## SUBDIVISION REVIEW SHEET

**CASE NO.:** C8-2023-0036.0A

**SUBDIVISION NAME:** Veranda Apartments

**CITY OF AUSTIN –DEVELOPMENT SERVICES DEPARTMENT  
SUBDIVISION APPLICATION – MASTER COMMENT REPORT**

# VERANDA APARTMENTS FINAL PLAT

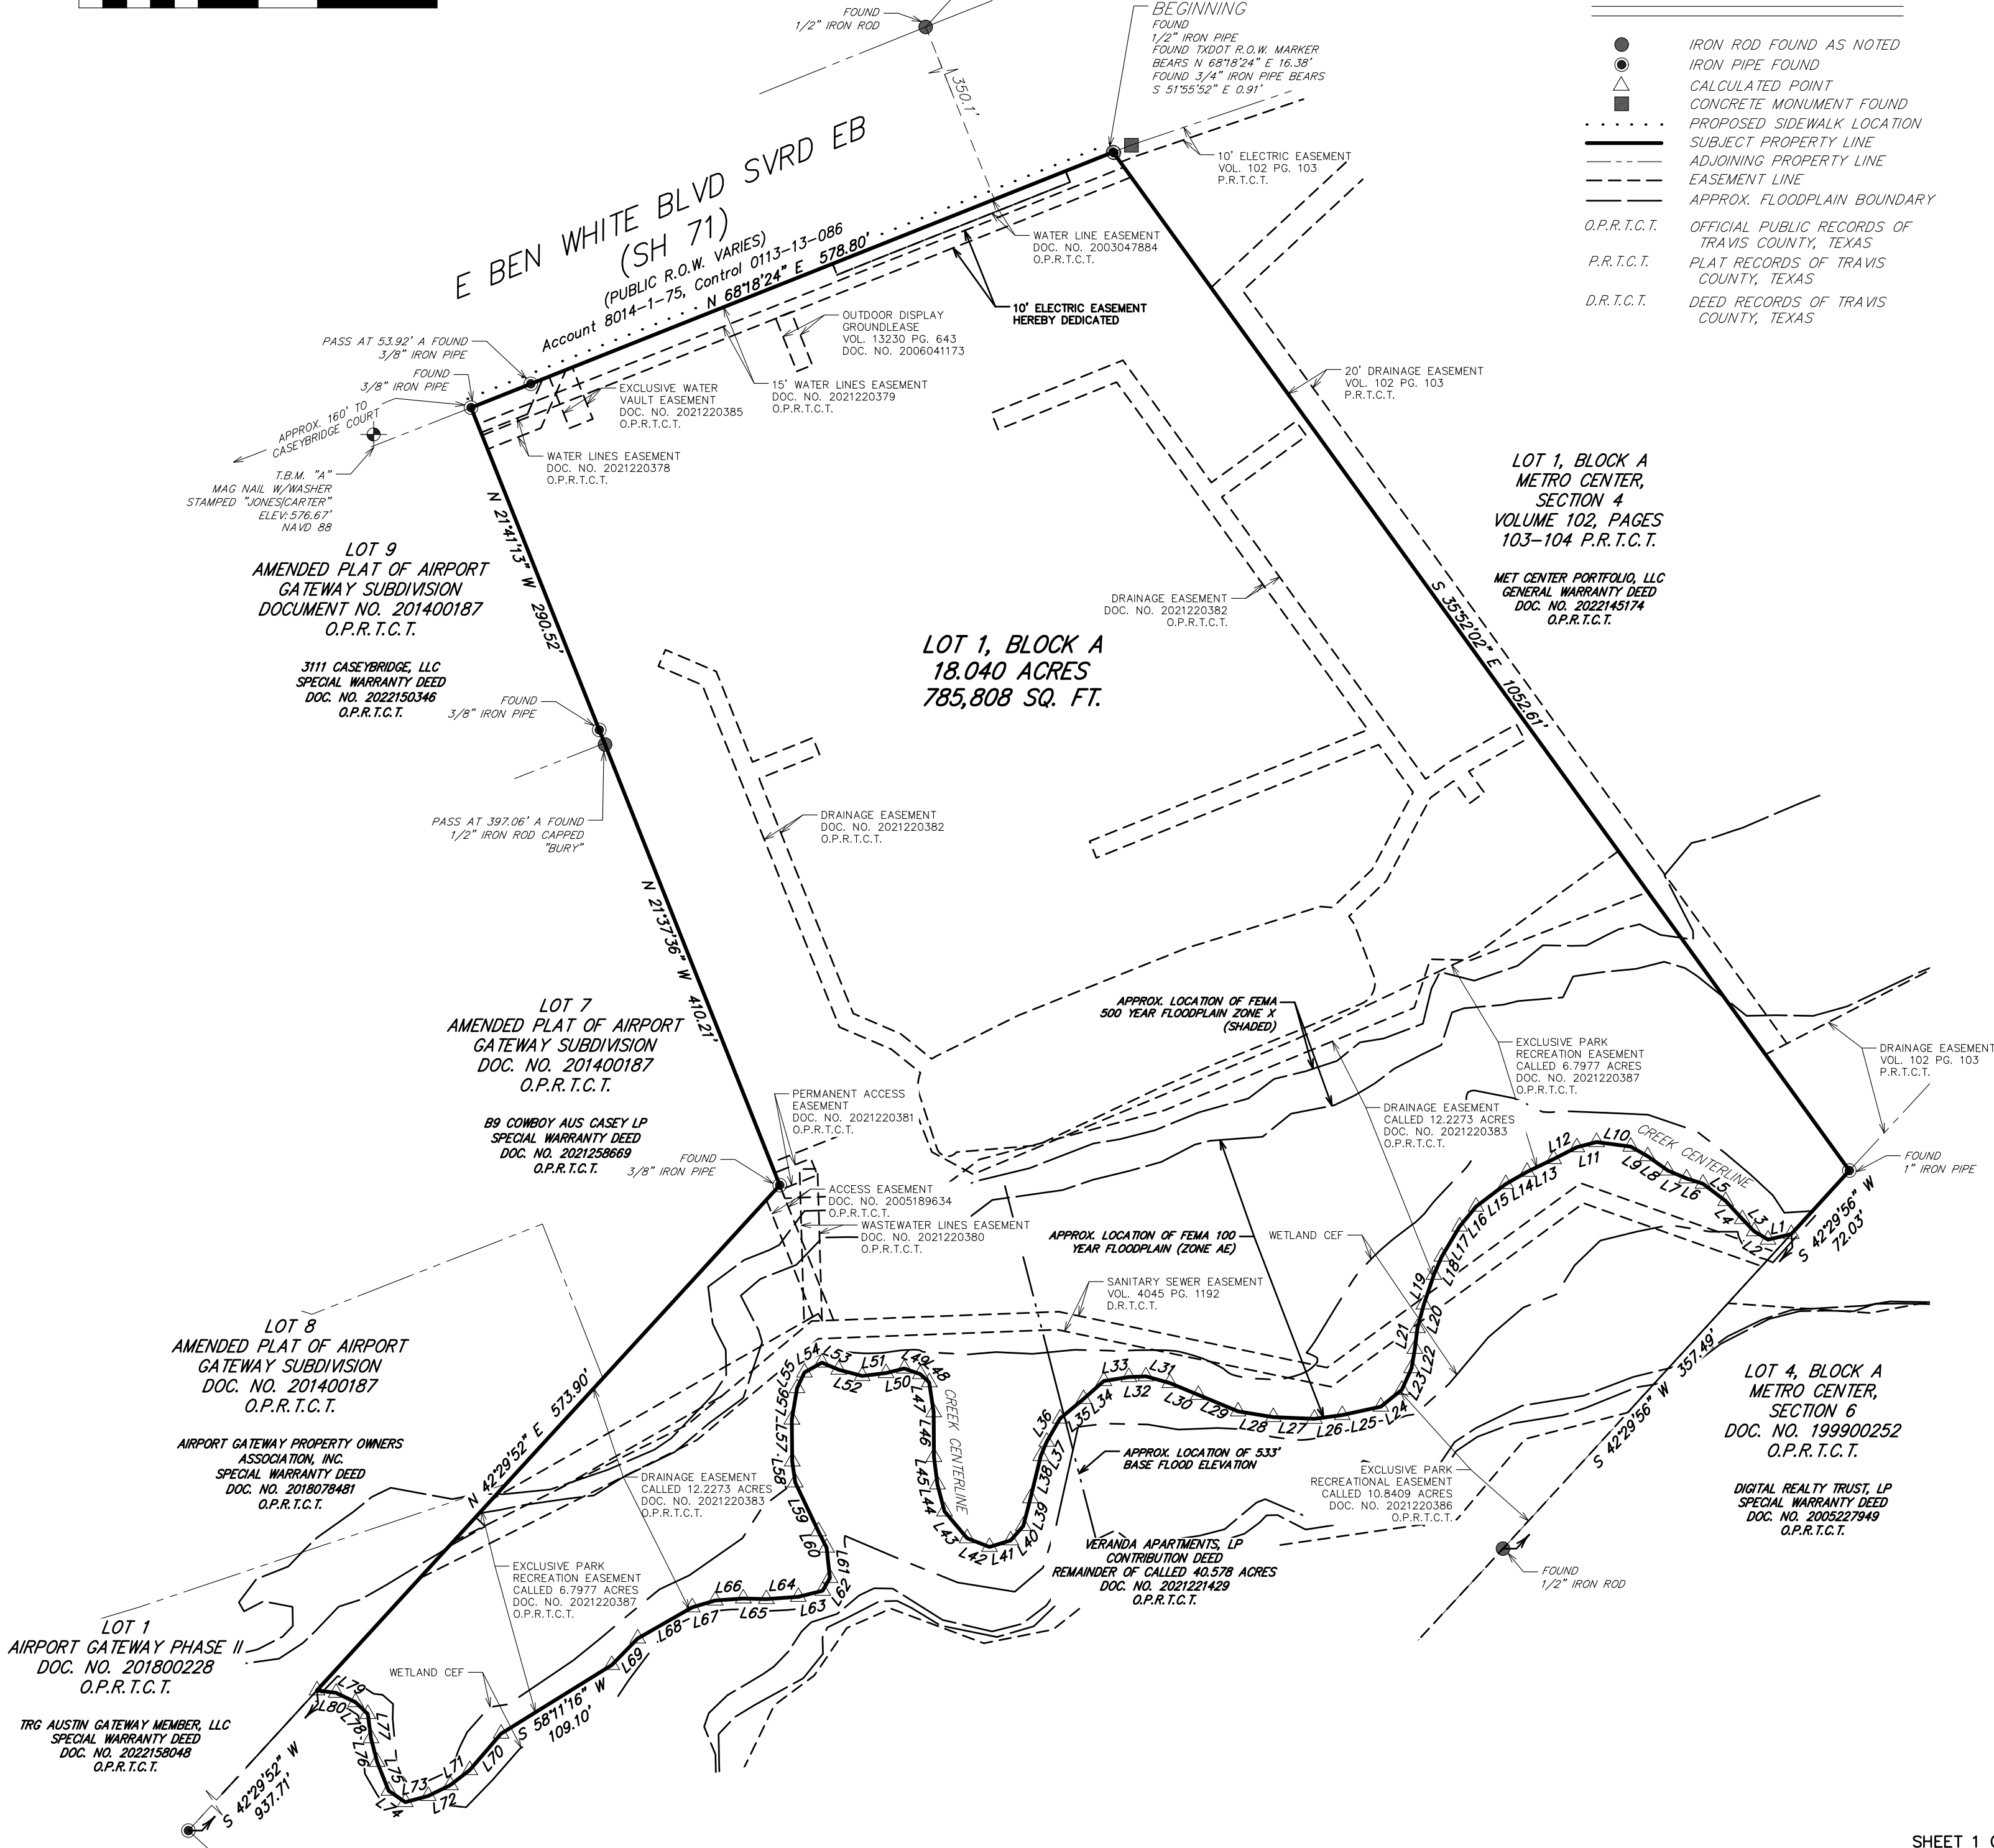
EL 1. U1: **Comment pending.** [LDC § 25-4-132 - EASEMENTS AND ALLEYS.](#)

Please relocate 10' electric easement to be directly adjacent to E Ben White Blvd R.O.W. above 15' water lines easement instead of behind it, and label it as a **10' aerial electric distribution, electric telecommunications, and electric fiber easement**. Aerial easement gives AE above-ground rights to access electric facilities on E Ben White and does not affect existing water easement or facilities on or below the ground.
